Planning and Development Strategy for the Canberra Brickworks and Environs

**Submission on the Canberra Brickworks + Environs Planning and Development Strategy February 2015
(Deadline 4 April 2015)**

Re: Submission – Proposed Canberra Brickworks and Environs Development 2015

Figure 2 – Opening up existing streets to the proposed development will greatly encourage “rat running” as traffic avoid the congestion of Cotter Road and YarraGlen.

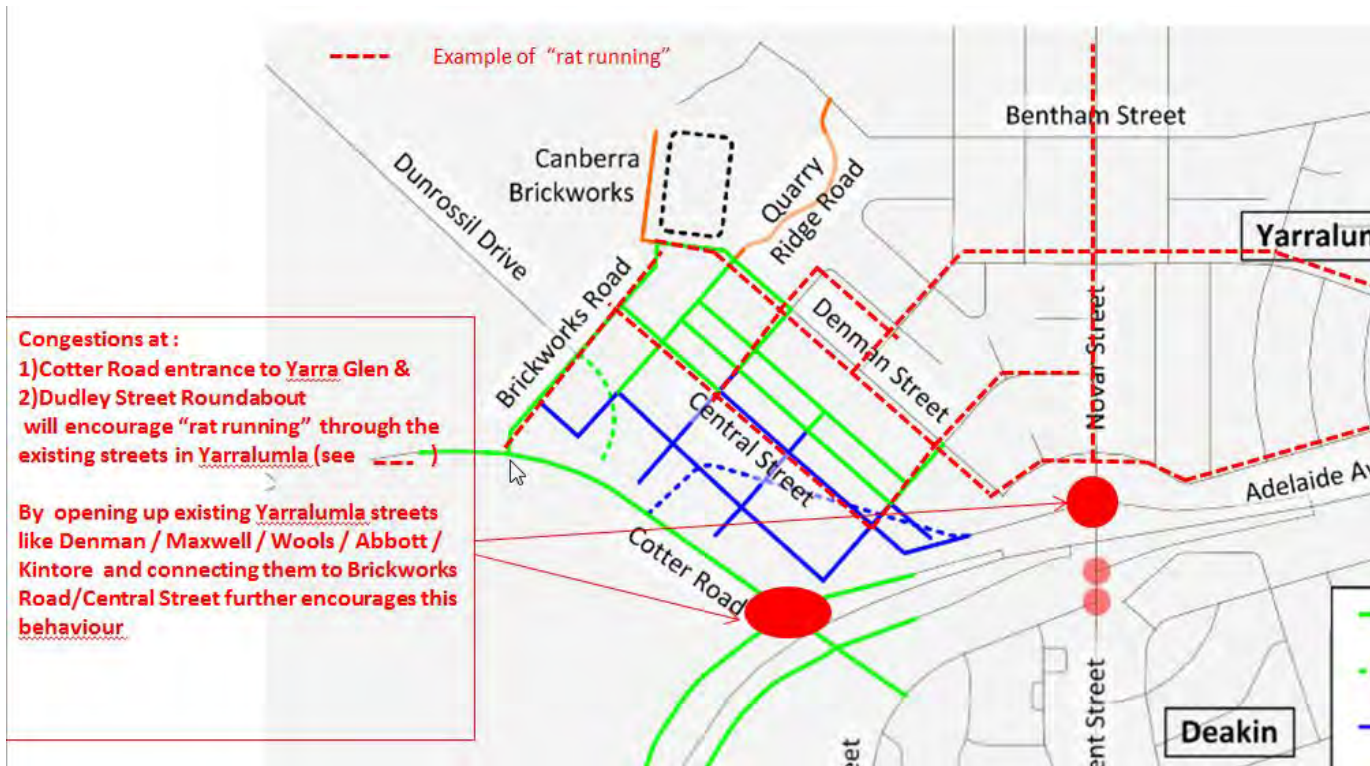
- a. The connection of existing roads to the proposed development will encourage “rat running” for traffic trying to avoid the congestion between Cotter road/YarraGlen and Adelaide Avenue during peak periods (see Figure 2). This includes traffic from the new Western Creek suburbs as well as additional traffic from the proposed development. This is in part acknowledged in The Traffic, Transport and Infrastructure Report, Part 2, which states that *“DudleyStreet still carries some rat - running traffic but the congestion is greatly relieved. With the added connectivity, traffic between Cotter Road and North Yarralumla is also seen to be using the Brickworks Road – Denman Street Woolls Street route as an alternative.”*

I believe that “rat running” will be significantly worse than predicted.

3. The traffic load to existing streets can be alleviated by **NOT** connecting the higher density proposed development to the existing streets in the suburb. So far there are no studies done on the impact of the additional traffic on these streets. Over the last 3 years the traffic flow into Novar Street has increased considerably with the opening of new suburbs in Western Creek.
